The Commission has issued the enclosed Amendment No. 51 to Facility License No. DPR-68 for the Browns Ferry Nuclear Plant, Unit 3. This amendment changes the Technical Specifications in response to your request of December 9, 1981 (TVA BFNP TS 170) related to a reload associated with fuel cycle 5 operation.

BROWNS FERRY NUCLEAR PLANT, UNIT NO. 3

AMENDMENT TO FACILITY OPERATING LICENSE

Amendment No. 51
License No. DPR-68

Figure 3.5.K-1
MCPR LIMITS

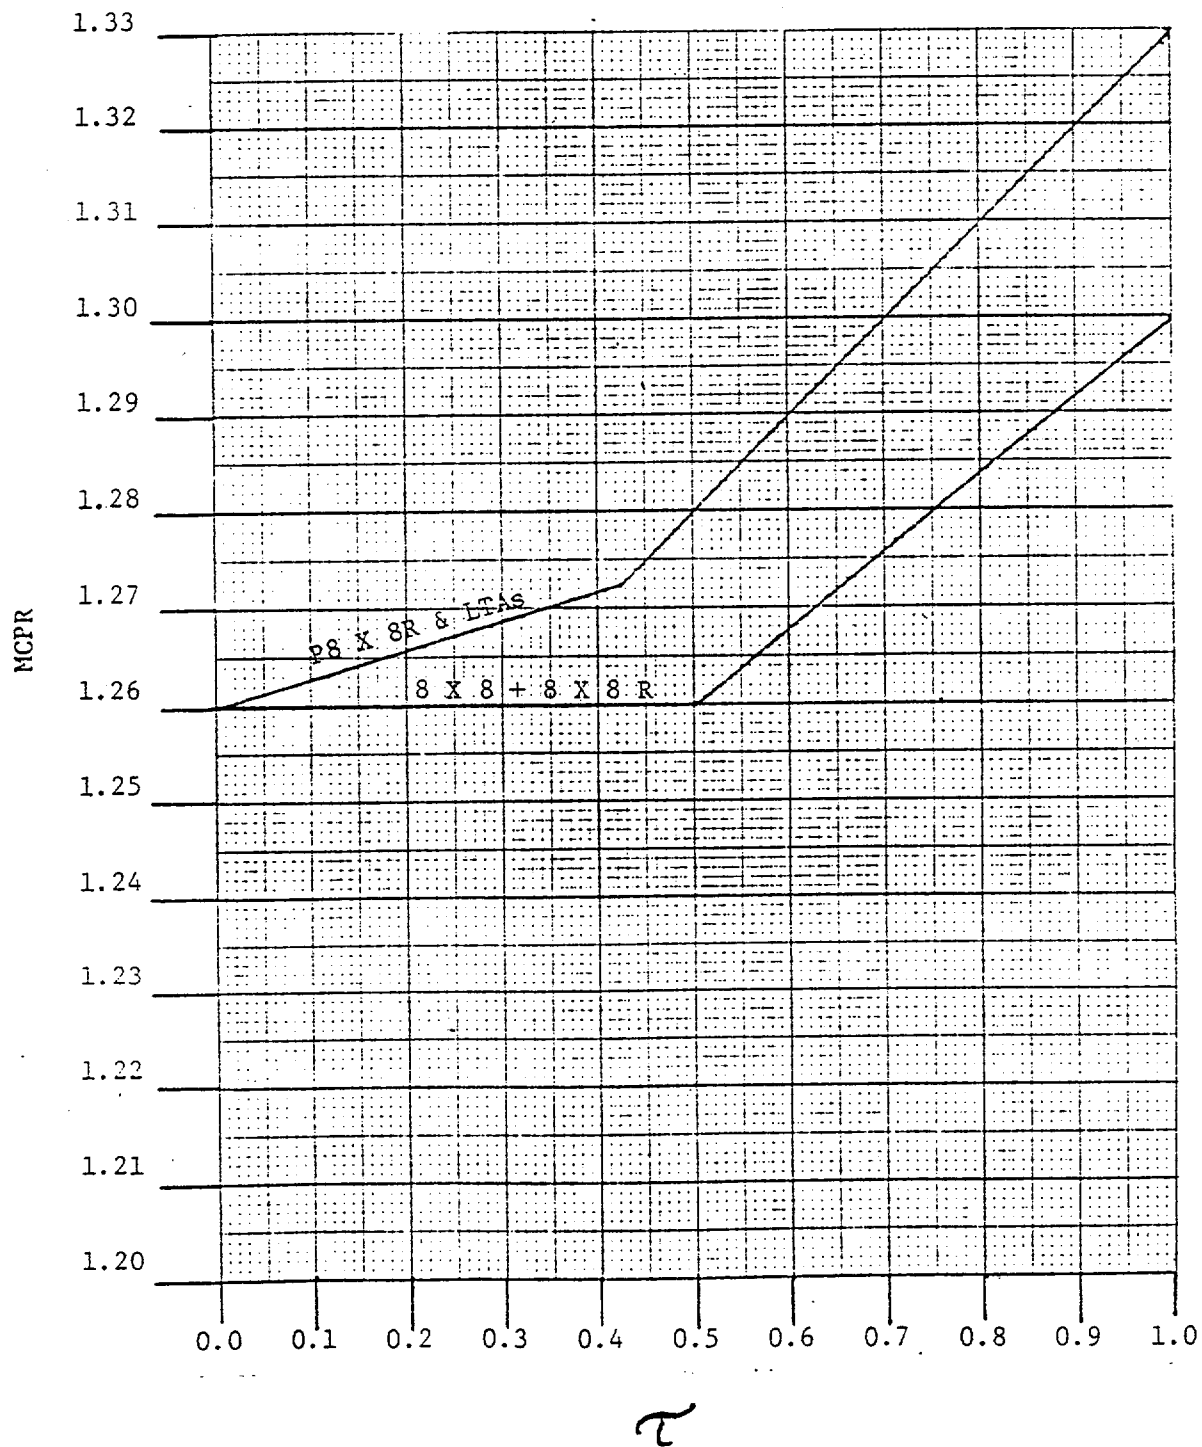
Pages ii, viii, 166, 167, 167a, and 182b - As supported by the reload submittal, the operating limit MCPRs are being changed. Since the MCPRs were determined by the ODYN code (rather than the REDY code), the OLMCPRs are now calculated from two curves rather than being a single value (or a ramp change with fuel exposure). Our evaluation was covered in Section 2.2.1 above.

The minimum critical power ratio (MCPR) as a function of scram time and core flow, shall be equal to or greater than shown in Figure 3.5.K-1 multiplied by the K_f shown in Figure 3.5.2, where:
